# SQUARE 487

COMMISSION OF FINE ARTS | CONCEPT REVIEW | 20 MAY 2021

SECOND SUBMISSION | FIRST REVIEW: 18 MARCH 2021

ROCKEFELLER GROUP | STONEBRIDGE

Further Study of the Top Stories

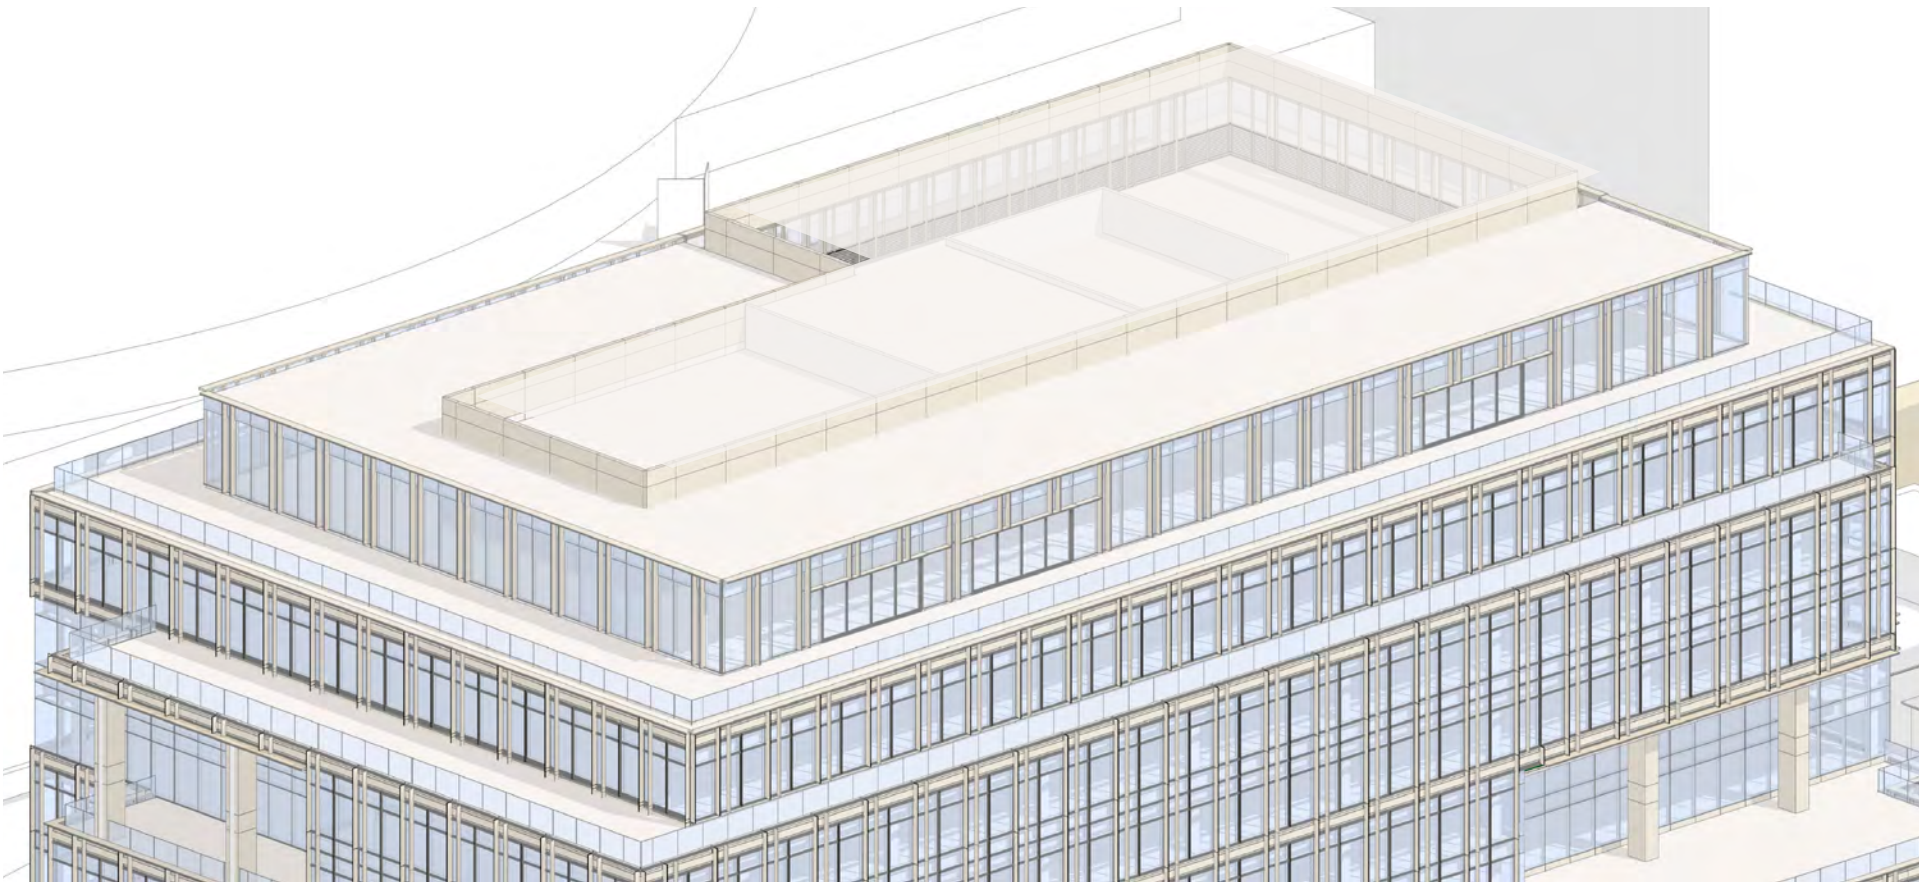
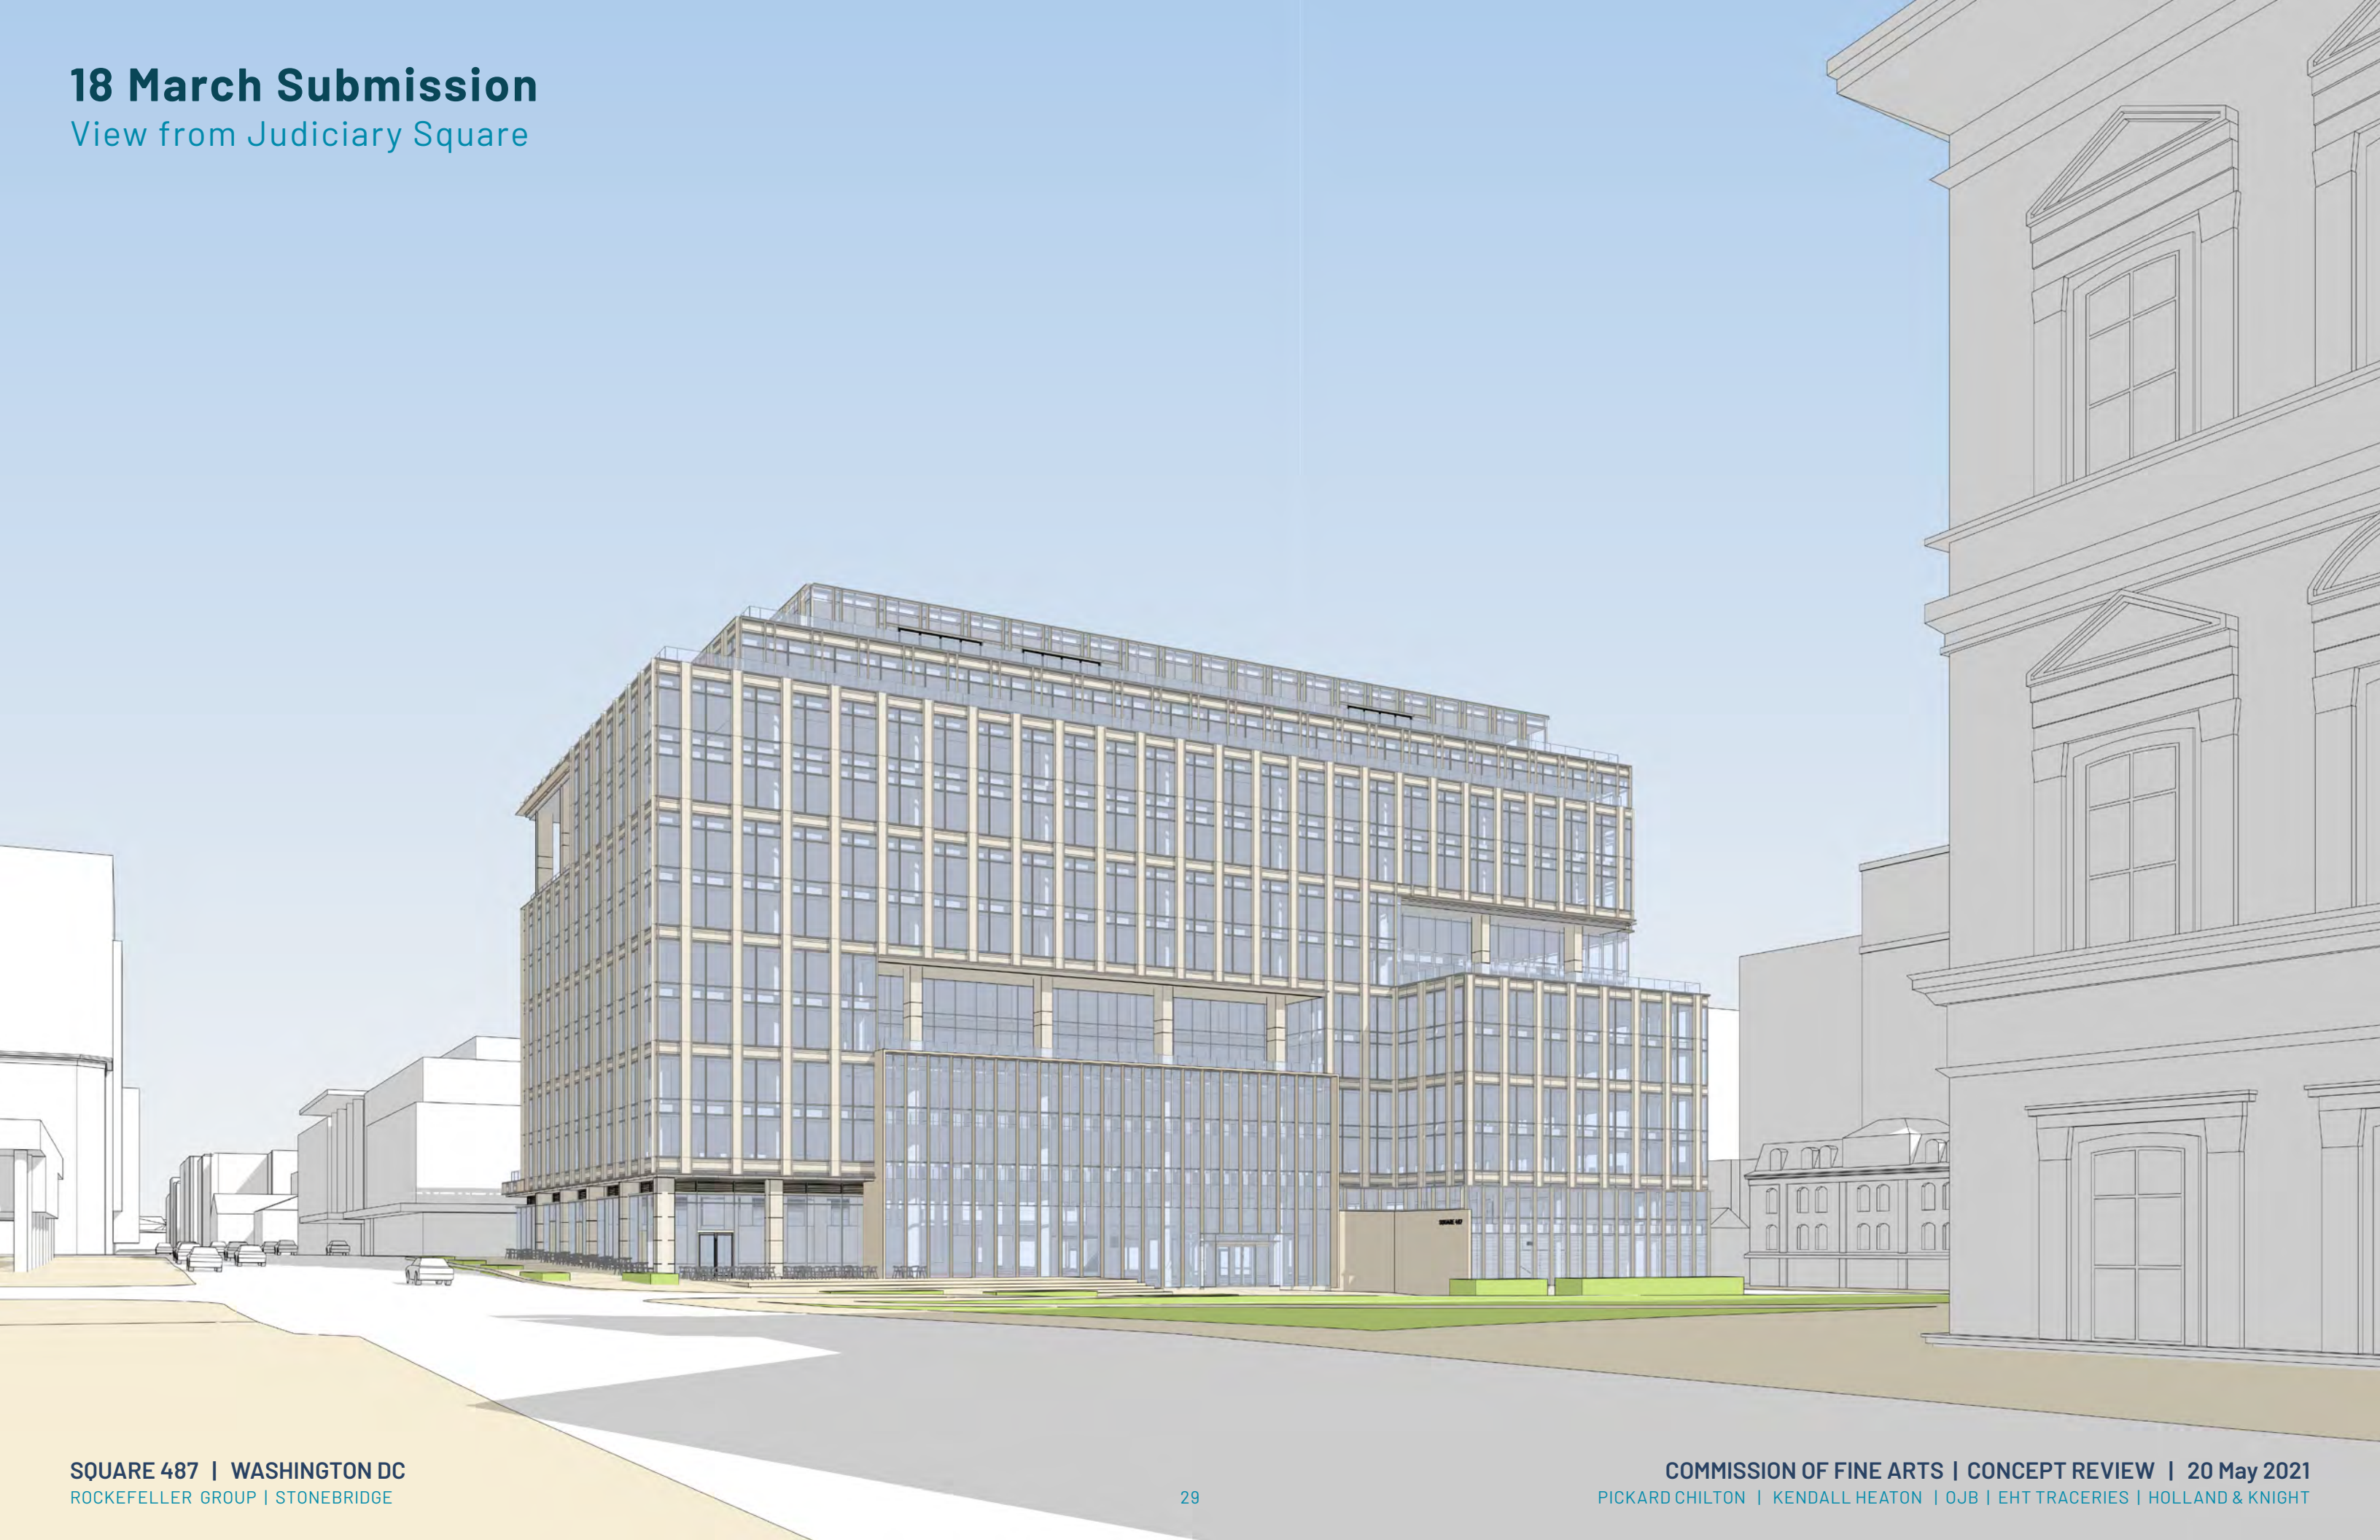
CFA Comment:

“...recommended further study of the top stories in order to minimize the impression of reflexive, incidental massing by reducing the number of step-backs and deliberately integrating the top into the overall composition of the building.”

**Penthouse** - Designed and developed options to reduce visual prominence, create shadow lines, and leverage system of brows and cornices to integrate with the overall building
